# The Greater Cambridge Design Review Panel

**Westbrook Centre, Westbrook Drive, Cambridge,  
CB4 1YG (22/50543/PREAPP)**

**14<sup>th</sup> September 2023**

Figure 2: Proposed Ground Floor Plan (NTS)

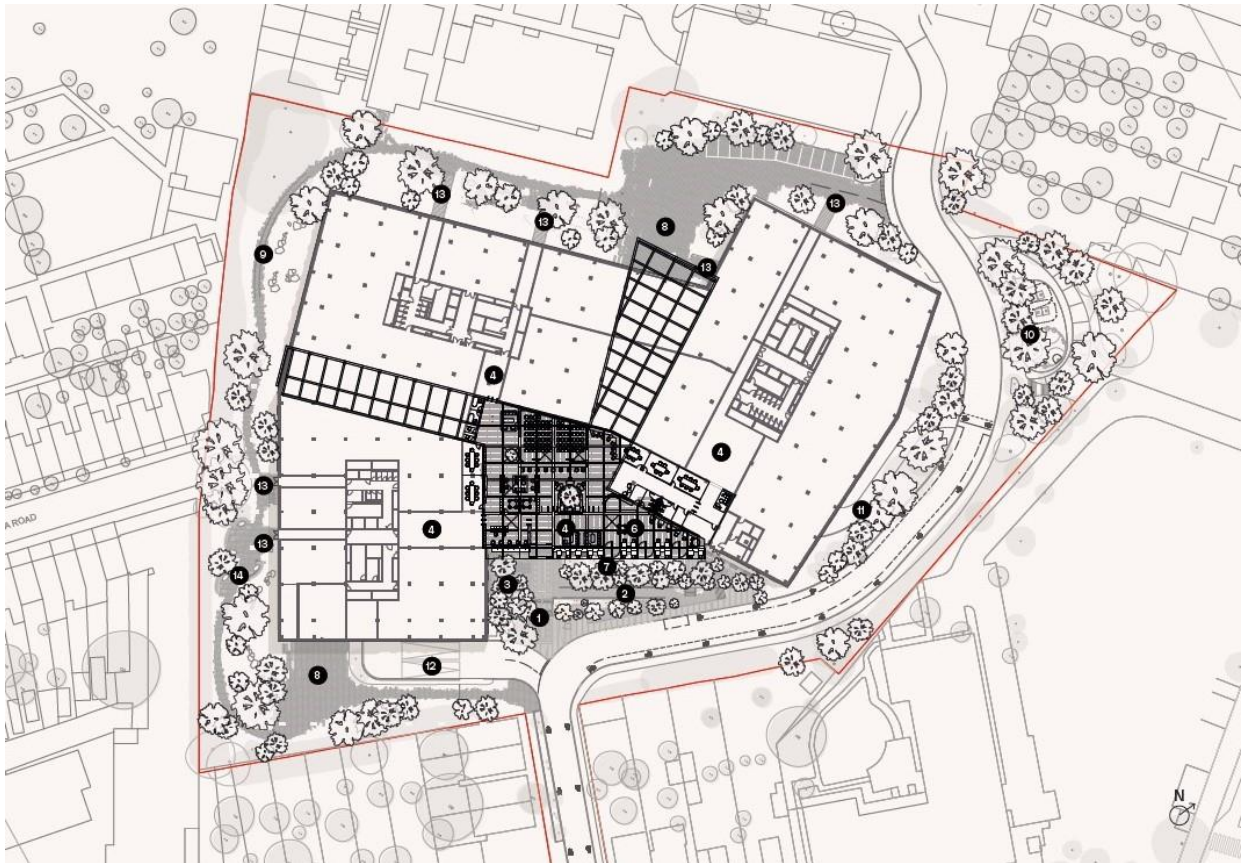
Noting the volume of car parking proposed in the under-croft, and despite the intended removal of most of the ground level spaces currently positioned around the site, the Panel is very concerned as to how the vehicle movements associated with 1700 workers - who will be arriving and leaving at the start and end of the working day - will not create a bottleneck (and this concern does not take into account deliveries). Despite the acceptance of proposed trip generation by the County Council as highway authority, the need for all of the vehicular parking proposed is challenged by the Panel. Although the design team refers to car parking numbers being reduced and there being 100 fewer spaces than existing (1 space per 130sqm is proposed), the Panel is firmly of the view that the development should be car-free (other than access for blue badge holders). Any car parking on-site that is provided should be sensitively managed, to ensure that there is as much permeability as possible; the numbers of spaces could gradually be reduced via leases and/ or s106 obligations, as modal shift occurs. Unless and until the development is car-free, cars arriving at the site should be decanted as soon as possible. The Panel suggests providing two access ramp points that could allow the under-croft to be split, and then it could be possible to bring the centre of the site down to grade. The access ramps should be inside the new buildings i.e. underneath them, so that they interfere less with the public realm.

Turning to cycle parking, the Panel has been given to understand that the highway authority accepts the number of spaces as meeting LTN standards. Short and long stay cycle parking is provided, plus space for cargo bikes. The number of cycle spaces is not however in line with the local plan standard of 2 spaces for every 5 staff, or 1 space per 30sqm gfa, whichever is the greater. Any shortfall in spaces should be addressed in the Panel's view because cycling is the key sustainable transport mode for the city and accessing the site for some 1700 employees; clarity

is also required on how all needs will be met. Placing cycle parking in the under-croft is not the optimal solution as it complicates routes for cyclists. The Panel suggests having most cycle parking provision at ground level across the site, activating and making Westbrook Drive and the landscape safer.
